## PAC Information Request – Wambo Mod 17

14 December 2017

Figure 1: Wambo mine surface and groundwater monitoring locations

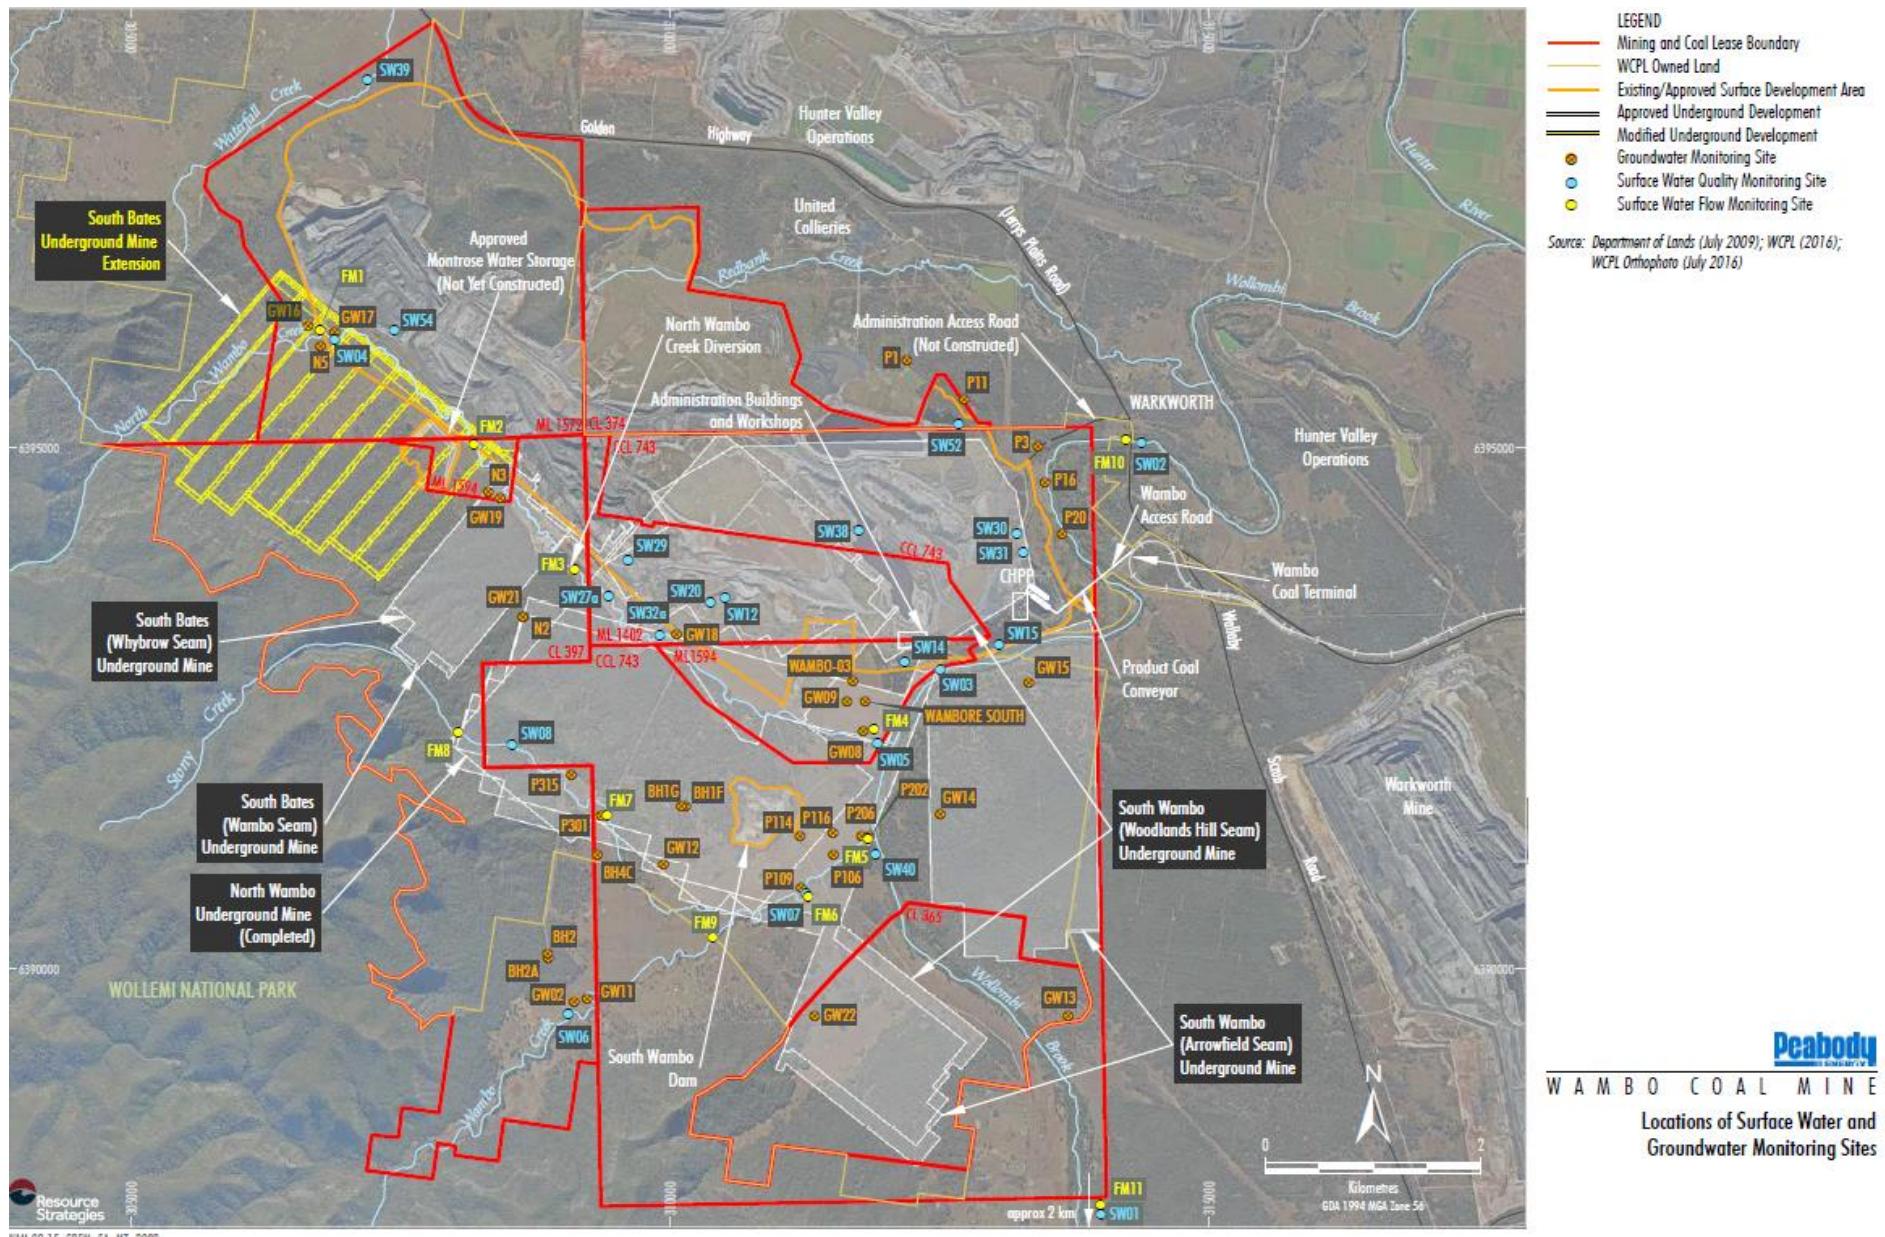
*Existing condition 34(a) includes requirements for the Ground Water Monitoring Program including detailed baseline data on ground water levels and quality etc. The Commission requests details of this*

*baseline monitoring, including where it is up to, what it has shown and the relationship to the MOD area?*

**Figure 1** shows the existing groundwater monitoring locations across the Wambo mine site. This includes monitoring locations within the proposed modification area, established for a number of years.

The numerical groundwater model used to predict expected impacts from the proposed modification was calibrated using observed groundwater levels at 86 groundwater monitoring sites during the period January 2003 to December 2014 (ie 11 years of monitoring data).

**Figure 2:** Plan of recent bores drilled adjacent to North Wambo Creek

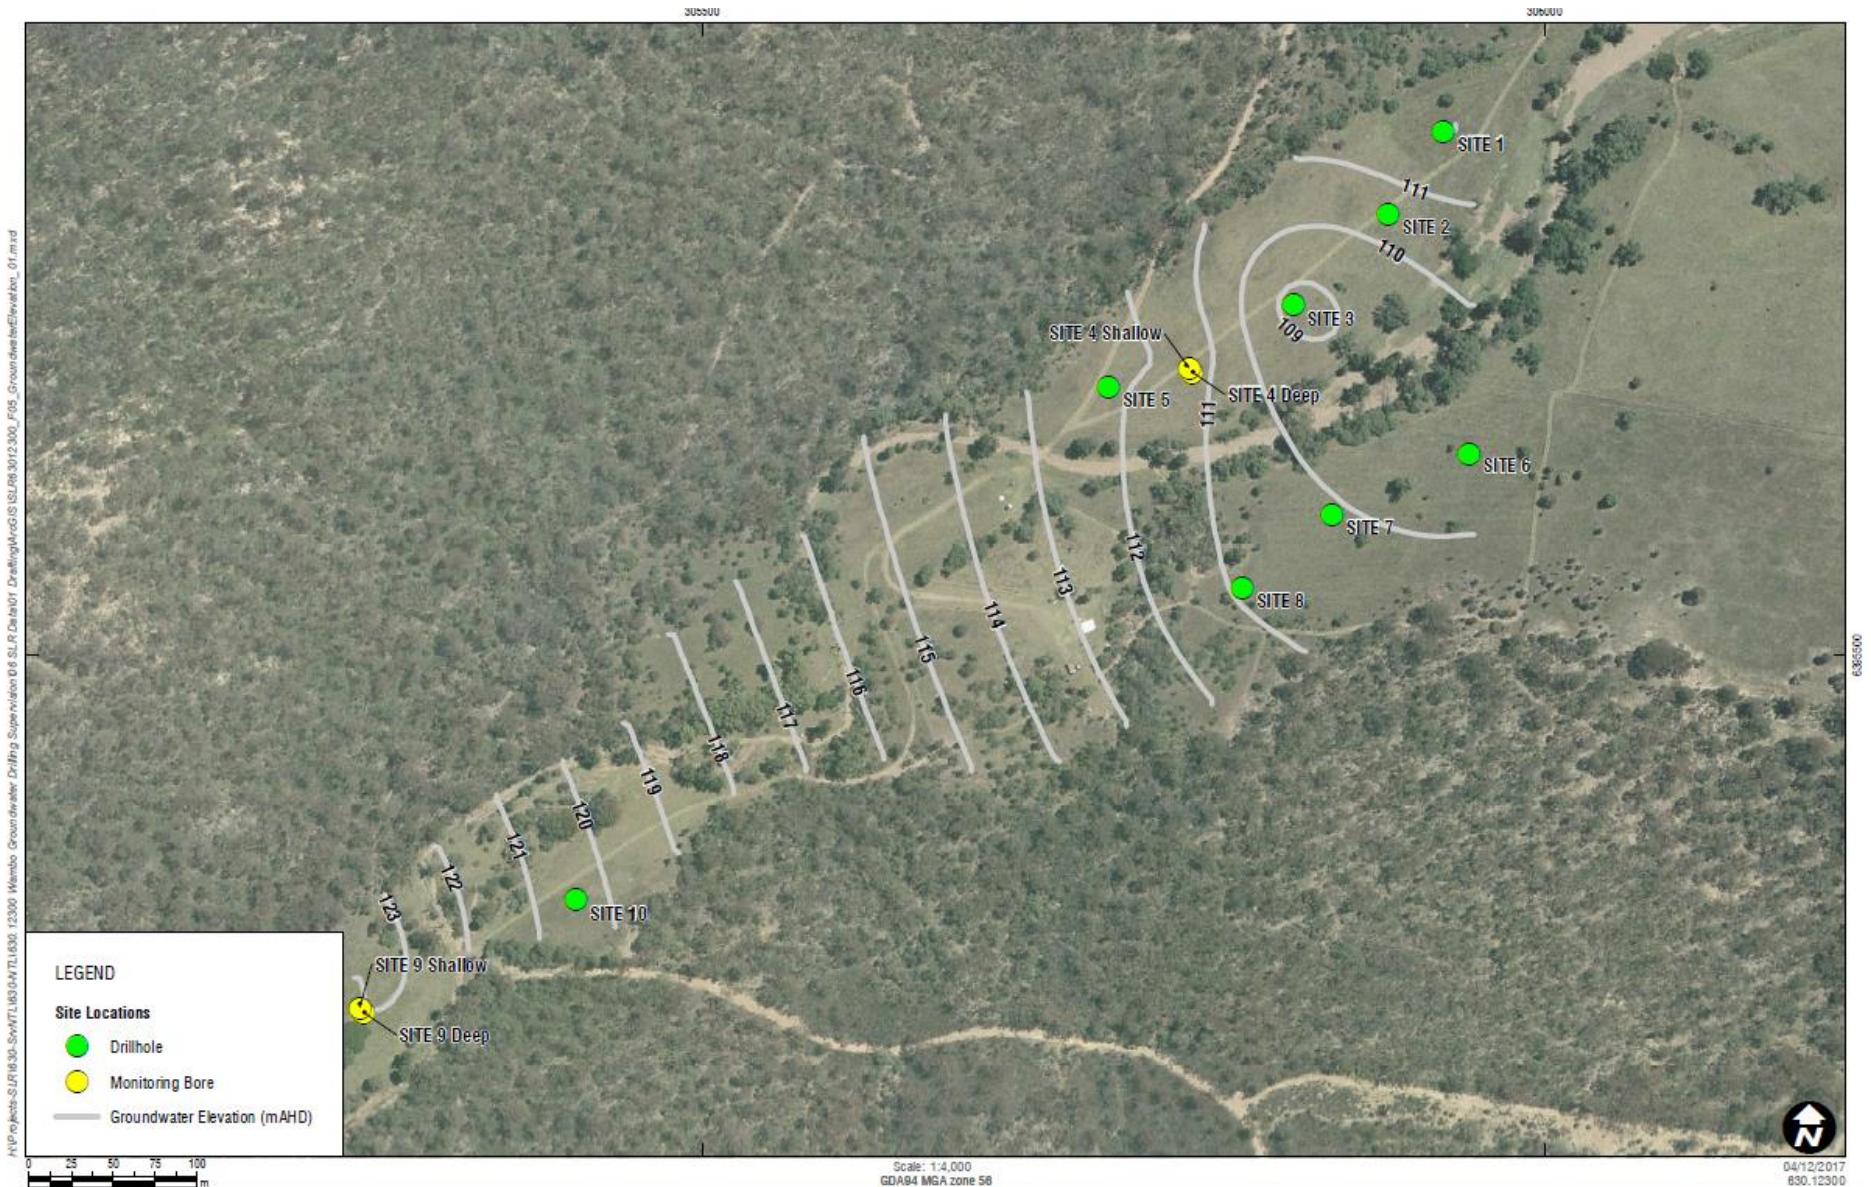
<b>CLWD comments of Wambo Mod 17 draft conditions (November 2017)</b>	<b>Department's consideration and recommendation</b>
<b>Condition 34(a) – Groundwater Monitoring Program</b>	
<ul style="list-style-type: none"><li>under the AIP, modelling for a mining project should be based on a minimum of 2 years of baseline data.</li></ul>	<p>The locations of groundwater monitoring sites at the Wambo mine site are shown in <b>Figure 1</b>. Within the proposed modification area there are three groundwater monitoring bores (GW16 and GW17 where bimonthly monitoring commenced in December 2009, and N5 where continuous monitoring commenced in August 2015).</p> <p>The Groundwater Impact Assessment provided in the EA for MOD 17 considered data collected from these locations in the groundwater modelling.</p> <p>This existing monitoring provides baseline data for the proposed modification area, in addition to monitoring locations within the adjacent and already approved South Bates underground mine.</p> <p>To address CLWD's concerns about baseline data, the Department has recommended condition 34B. This requires that clustered monitoring bores (located close to potential groundwater dependent vegetation) and vibrating wire piezometers are installed in the modification area within 12 months of approval.</p> <p>Given likely mine scheduling, this would provide, (in addition to existing monitoring data), in excess of 2 years of baseline data within the contentious part of the proposed modification area. The Department notes that the longwall panels of concern to CLWD (LW23-25) would be the last panels extracted.</p> <p>WCPL has advised that on 21 November 2017 it established four permanent monitoring bores (including installing piezometers) across two sites to allow long term recording of groundwater levels</p>

<p>around North Wambo Creek, above proposed LW 25 (see <b>Figure 2</b>).</p> <p>The installation of these monitoring bores would provide an even longer period of baseline data within the modification area. As the longwall panels proposed in this location would be some of the last extracted (LWs 23-25).</p> <p>As part of the same program WCPL also completed investigative drilling to measure groundwater levels in the unconsolidated sediments.</p> <p>The Department understands that WCPL has received correspondence from CLWD that supports this drilling campaign and requested additional drill holes.</p> <p>The existing Extraction Plan condition (condition 22C) also requires that sufficient baseline data is collected to inform future Extraction Plans.</p> <p>The Department considers that adequate baseline data either is or would become available for each element of the proposed modification.</p>
